ITEM: 6.11	REPORT SUMMARY MINOR VARIANCE APPLICATION FILE NUMBER A235/22
-------------------	--

MINOR VARIANCE APPLICATION FILE NUMBER A235/22

CITY WARD #:	1
APPLICANT:	Harwinder & Jessica Kalsi
AGENT:	PMP Design Group Inc
PROPERTY:	15 Cardish Street, Kleinburg
ZONING DESIGNATION:	See below.
VAUGHAN OFFICIAL PLAN (2010) DESIGNATION:	Vaughan Official Plan 2010 (VOP 2010): "Low-Rise Residential"
RELATED DEVELOPMENT APPLICATIONS:	None
PURPOSE OF APPLICATION:	Relief from the Zoning By-law is being requested to permit a pergola (on Part 1) and cabana (on Part 2), a swimming pool (hot tub), the location of pool equipment in the easterly side yard and reduced landscaping requirements in the rear yard.

To: Christine Vigneault, Committee of Adjustment Secretary Treasurer
From: Nancy Tuckett, Director of Development Planning
Date: September 19, 2024
Name of Owner: Harwinder Kalsi
Location: 15 Cardish Street
File No.: A235/22

TITLE: 15 Cardish street
DWG: **SITE PLAN**
MUNICIPAL FILE No.: **A1**
PROJECT No.: 624

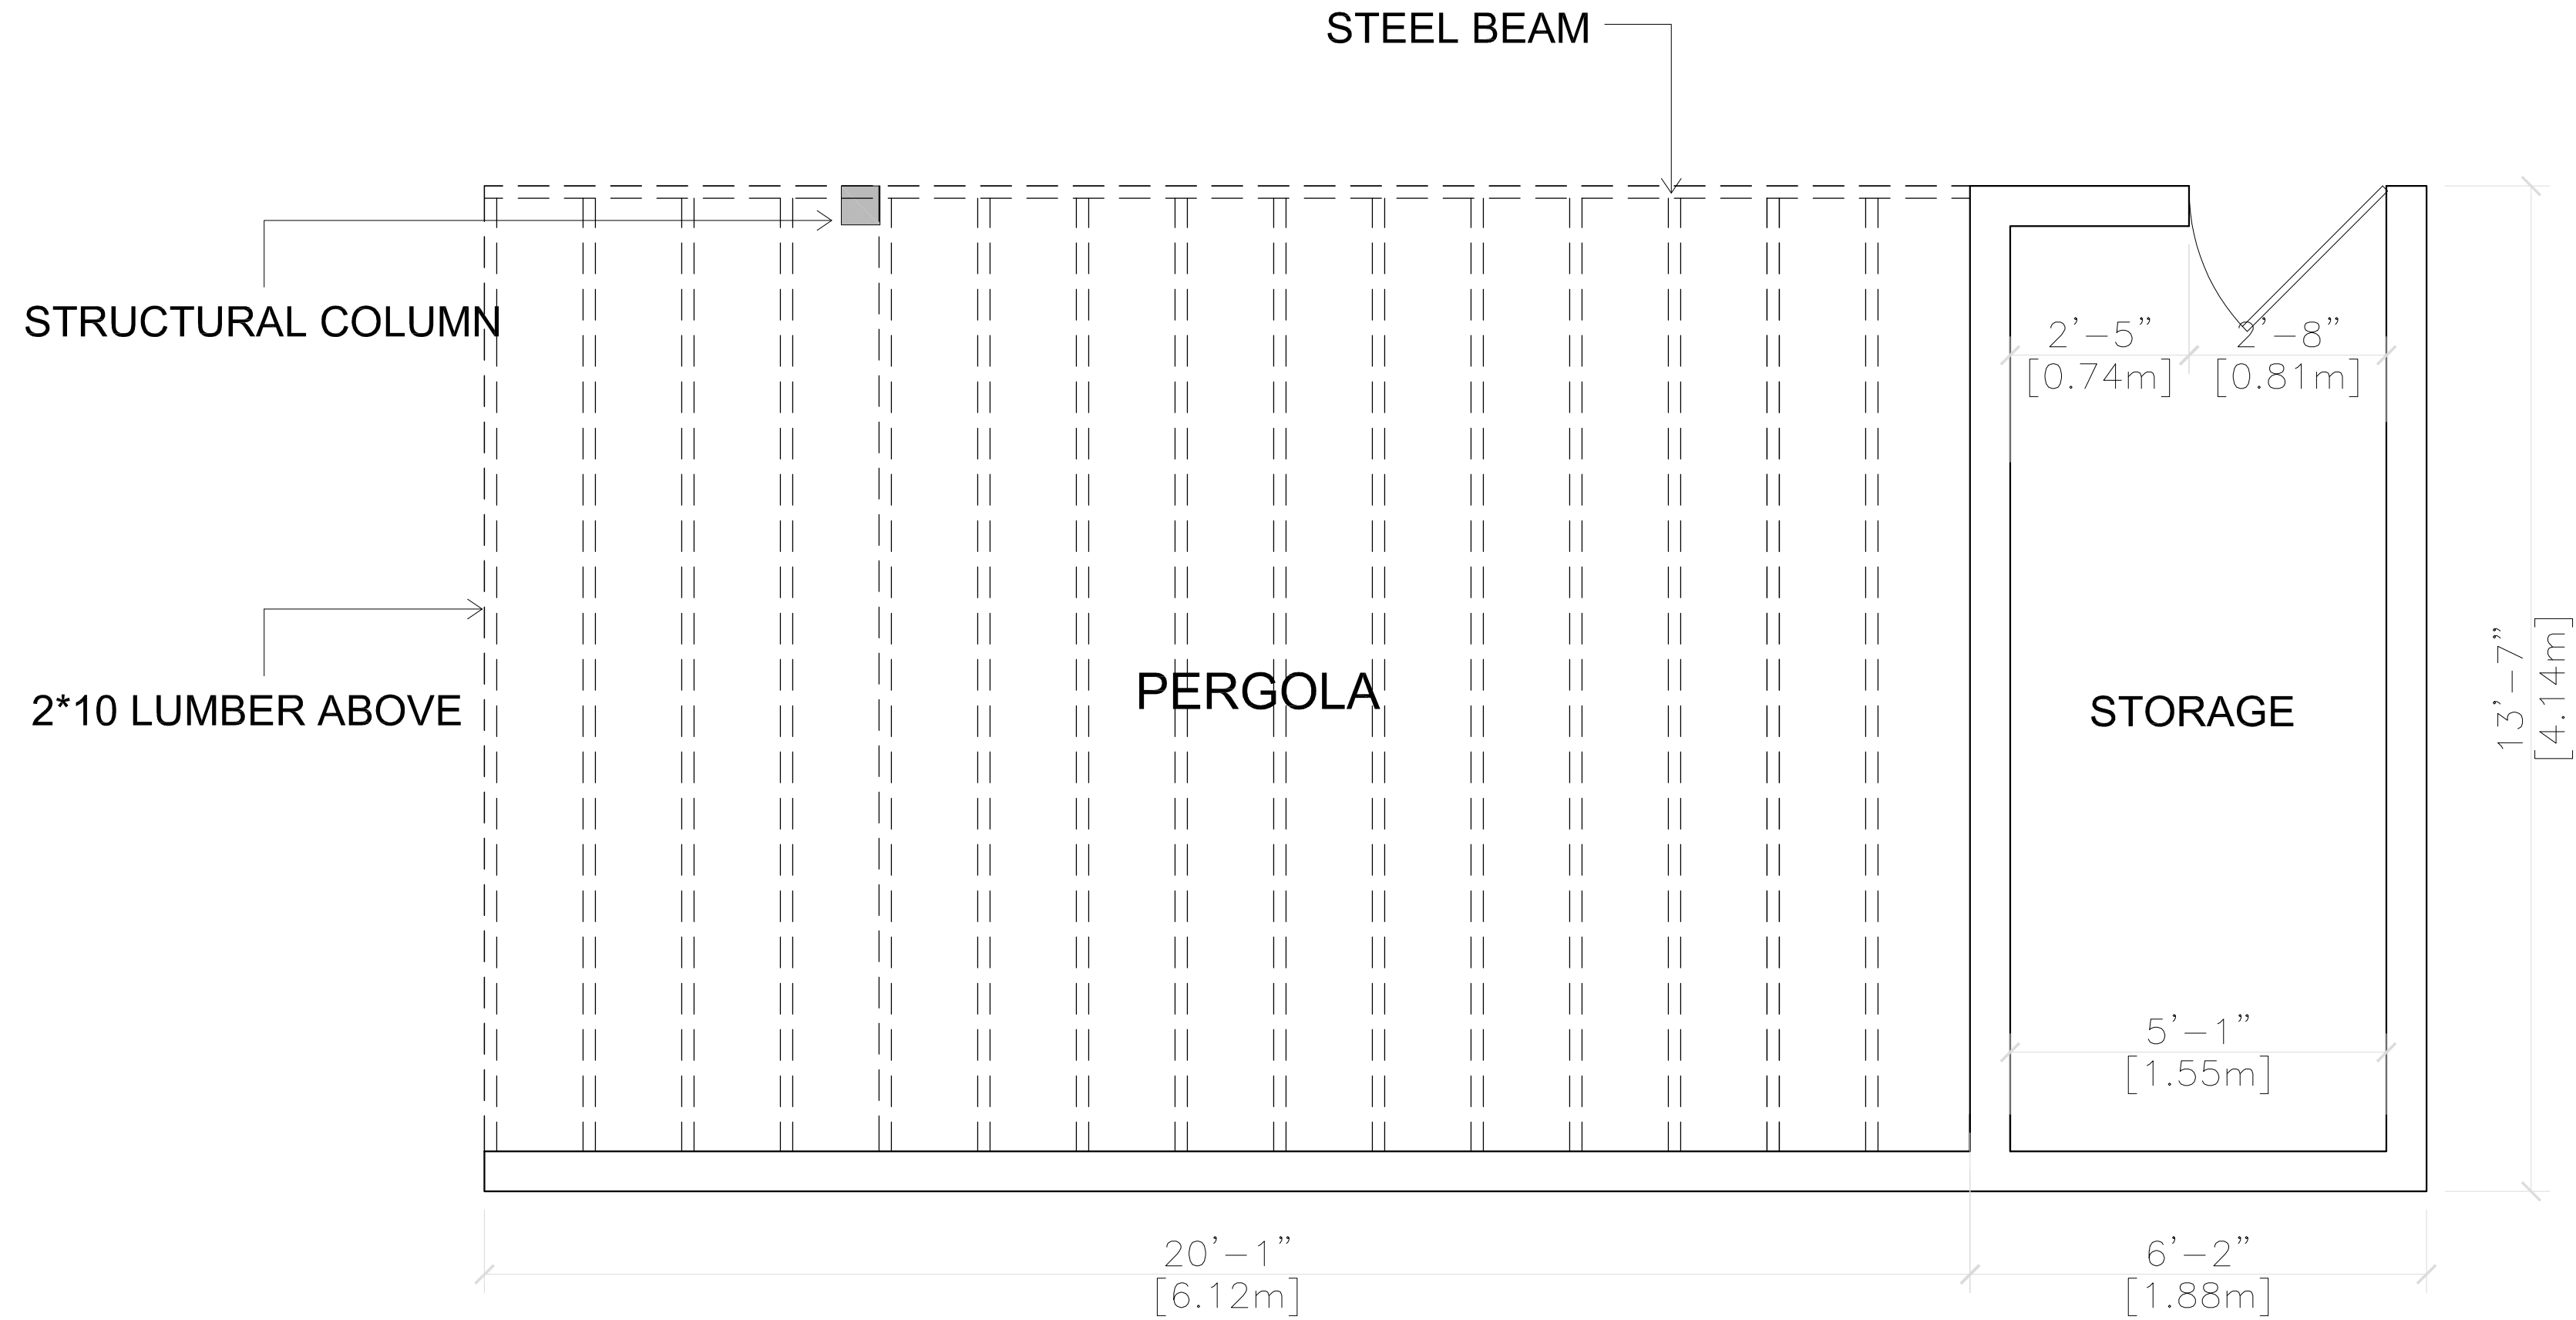
The Development Planning Department has no objection to Variances 1 and 4 to permit reductions to the minimum required distances from the westerly interior side lot line (Variance 1) and rear lot line (Variance 4) for the partially constructed pergola with an

The Development Planning Department has no objection to Variances 2 and 5 to permit encroachments into the minimum required distances from the easterly interior side lot line (Variance 2) and rear lot line (Variance 5) for the proposed cabana which is partially constructed with an enclosed storage room (identified as part 2 on the site plan) that has a maximum height of 3.18 m. The cabana is proposed to have a flat roof design with the requested relief measured between the established grade to the top of the roof. The cabana is proposed to be enclosed on all but the west side facing the pool with the exception of the storage room at the rear which will be fully enclosed and combines for less than half of the length of the accessory structure. The proposed minimum setbacks from the interior side lot line (0.65 m) and rear lot line (2.03 m) for the cabana are not anticipated to pose significant adverse impacts to the abutting property to the east (21 Cardish Street) or the south (38 Rushworth Crescent) as the eave projections are minimal. Sufficient space for maintenance and safe access is provided between the cabana and the property lines and an adequate amount of space between the structure and the dwelling are also provided to mitigate potential adverse massing impacts along the east lot line. Adverse massing impacts resulting from the cabana's east wall's proximity to the east lot line due to its length is further mitigated by the existing tall wooden privacy fence. 21 Cardish Street contains a number of mature trees along the mutual interior side lot line, providing a vegetative buffer between its rear yard and the cabana considered in this application. Additionally, at the rear, the cabana abuts an existing residential accessory structure in the rear yard of the abutting property to the South (38 Rushworth Crescent). Development Engineering Department Staff have also reviewed the proposal and are satisfied that drainage will be maintained. As such, staff are of the opinion that the proposed cabana will have minor massing and visual (privacy) impacts on the properties to the south and the east.

The Development Planning Department has no objection to Variance 6 to permit an increased maximum lot coverage of 40.95%. The proposed 0.95% increase to the allowable maximum lot coverage is negligible from a visual perspective and provides sufficient area for rear yard amenity space. As such, no adverse impacts are anticipated to the neighbouring properties, the function of the Subject lands, or the character of the existing neighbourhood, should the variance be granted.

The Development Planning Department has no objection for the proposed reduction (42.24%) in soft landscaping in the rear yard (Variance 7). River rock runs along both interior side lot lines and the entirety of the rear lot line. Development Planning Staff are satisfied with various number of planting boxes proposed along the rear lot line which could provide opportunity for future vegetative plantings if desired. Permeable interlocking is also proposed around the entirety of the pool to help alleviate stormwater runoff. Development Engineering Staff have also reviewed the application and do not have any concerns regarding drainage in the rear yard. As such, Development Planning Staff are of the opinion that the proposed reduction in rear yard soft landscaping is desirable and appropriate for the development of the land and does not adversely impact the surrounding neighbours or character of the existing neighbourhood.

DWG.
PROPOSED PERGOLA PART #1

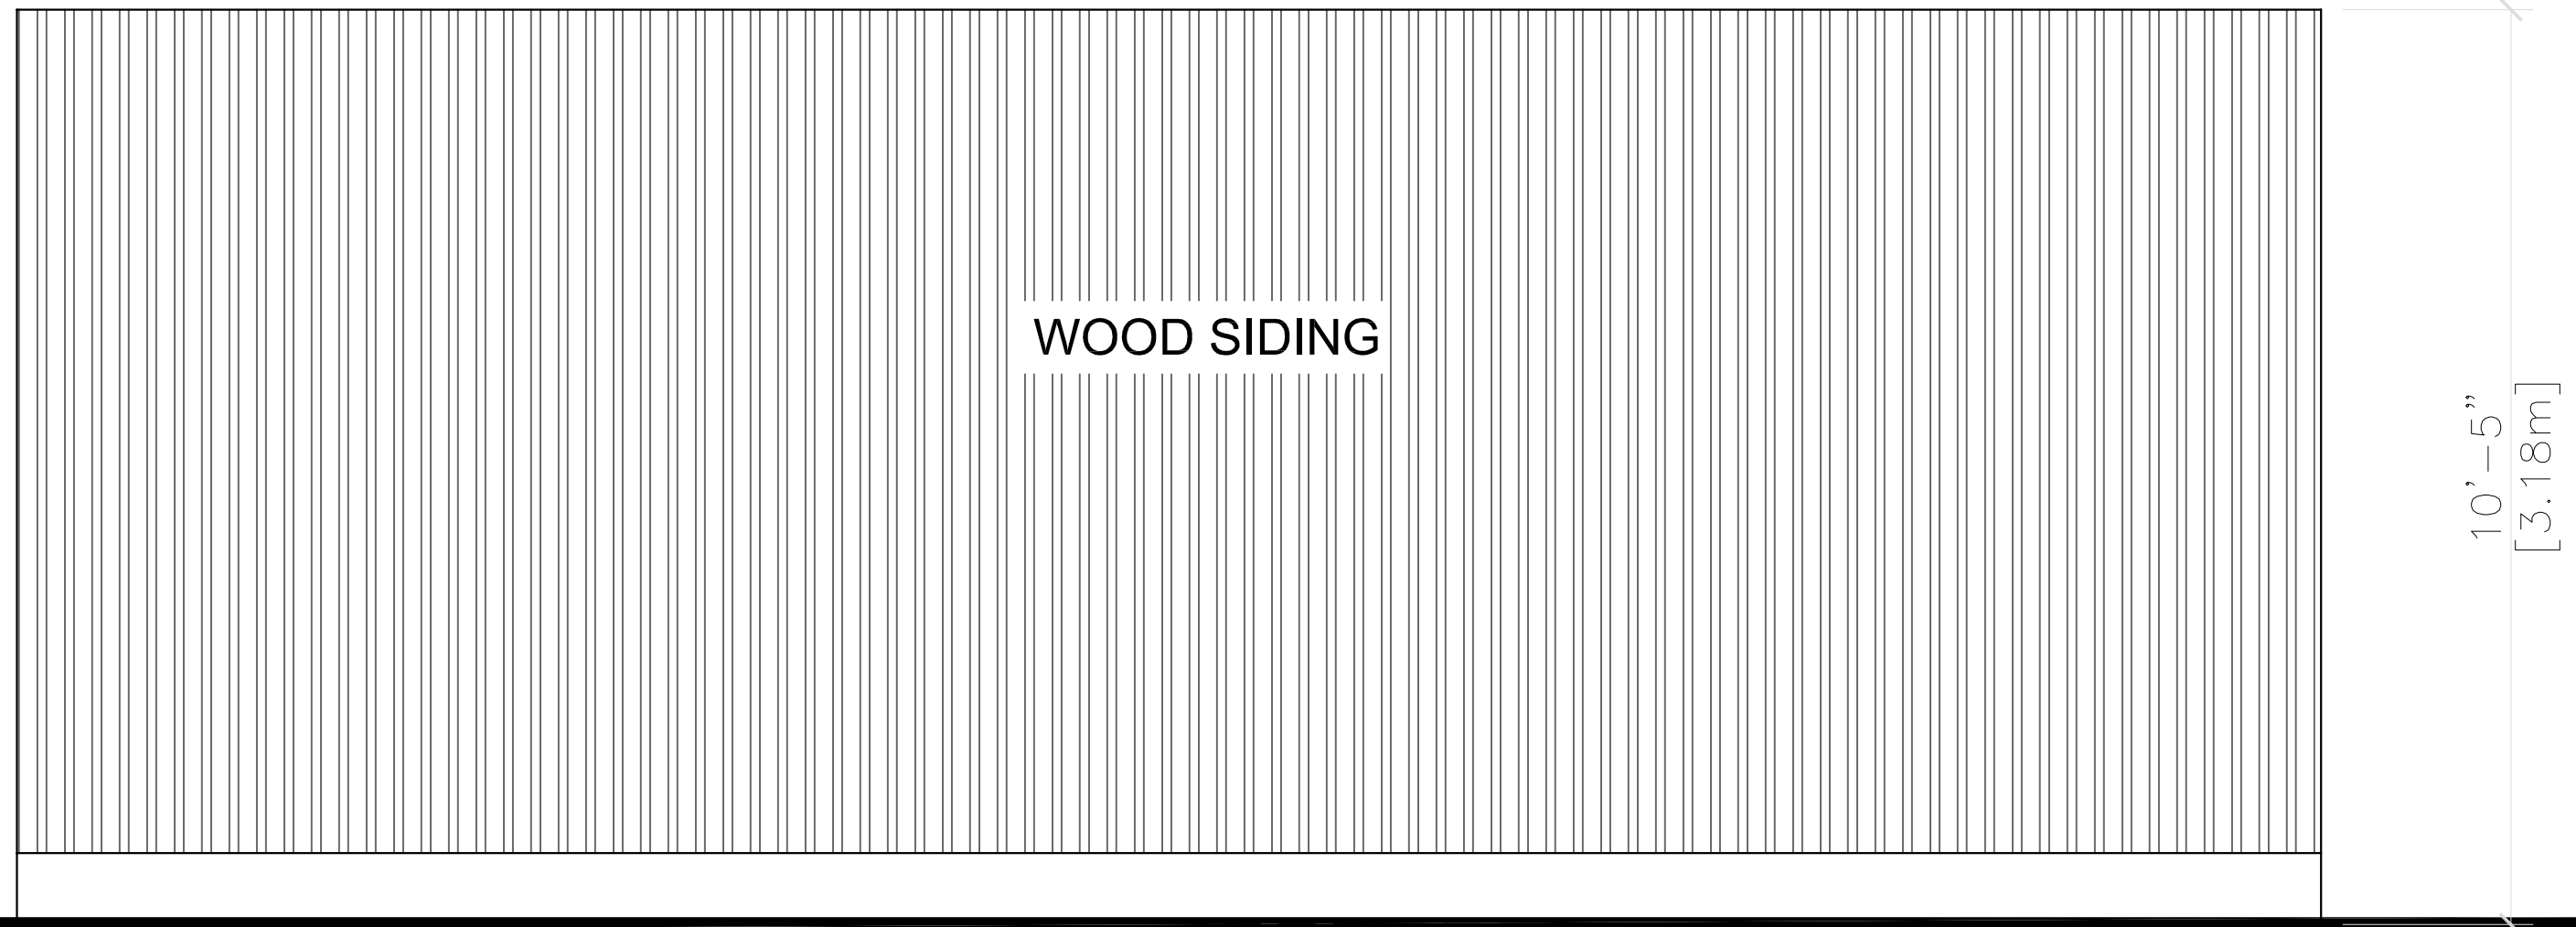
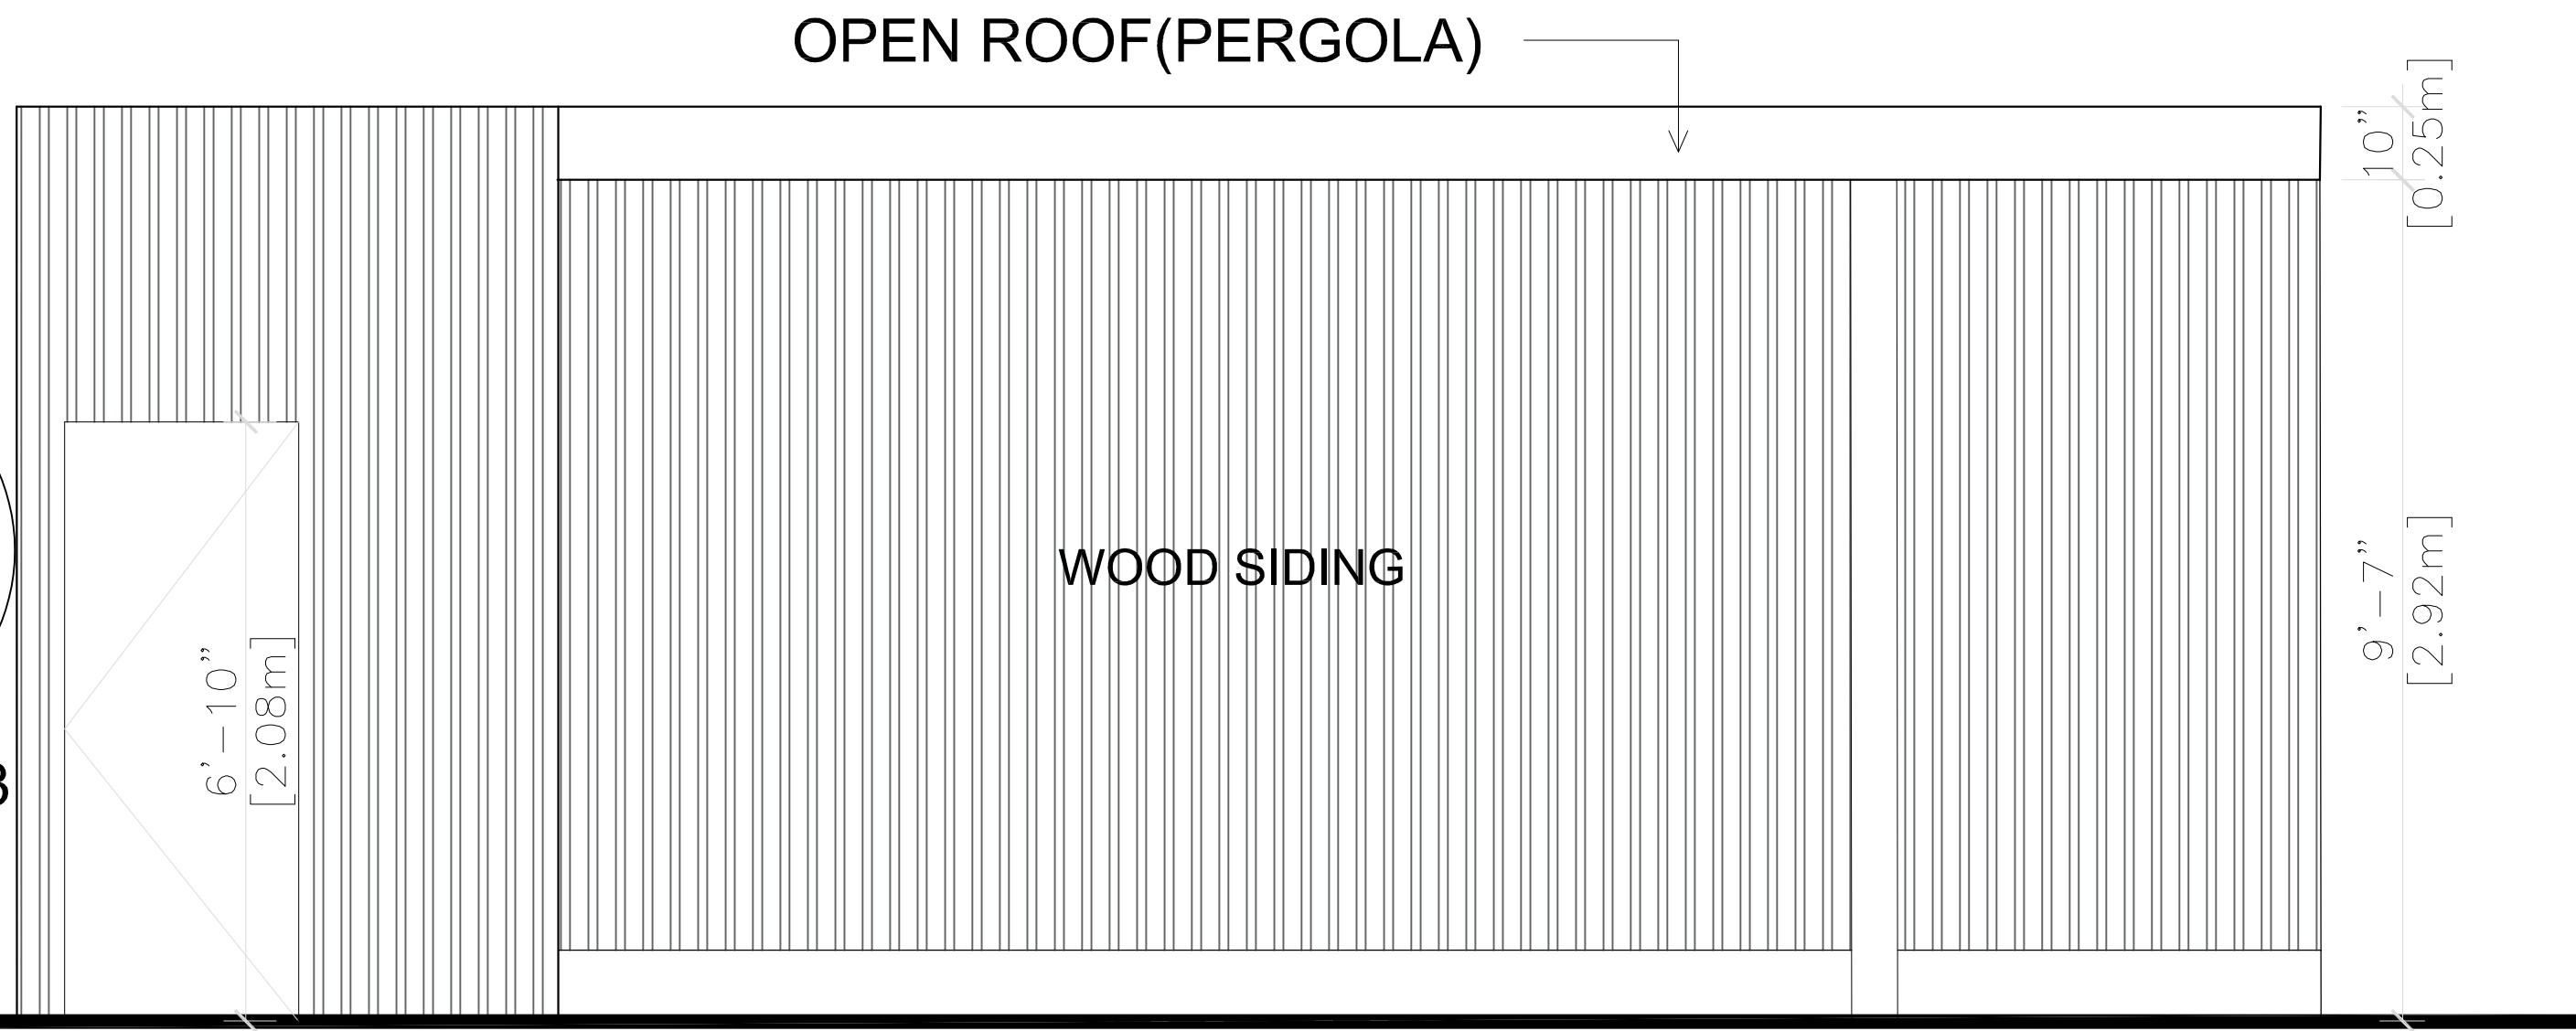
enclosed storage room (identified as part 1 on the site plan) that has a maximum height of 3.18 m. The pergola is proposed to have a flat (pergola style) roof design with the requested relief measured between the established grade to the top of the roof. The pergola is proposed to be open on all sides with the exception of the storage room at the rear which will be fully enclosed and combines for less than half of the length of the accessory structure. The proposed minimum setbacks from the interior side lot line (0.77 m) and rear lot line (2.03 m) for the pergola are not anticipated to pose significant adverse impacts to the abutting property to the west (19 Art Drive) or the south (5 Art Drive) as there are no eaves and the overhang does not overhang the property line. Sufficient space for maintenance and safe access is provided between it and the property lines and an adequate amount of space between the structure and the dwelling are also provided to mitigate potential adverse massing impacts along the west lot line. Adverse massing impacts resulting from the pergola's proximity to the west lot line due to its length is further mitigated by the absence of an enclosing wall (with the exception of the storage room) which was removed by the owner at the request of City staff. Development Engineering Department Staff have also reviewed the proposal and are satisfied that drainage will be maintained. As such, staff are of the opinion that the proposed pergola and associated storage room will have minor massing and visual (privacy) impacts on the properties to the west and south.
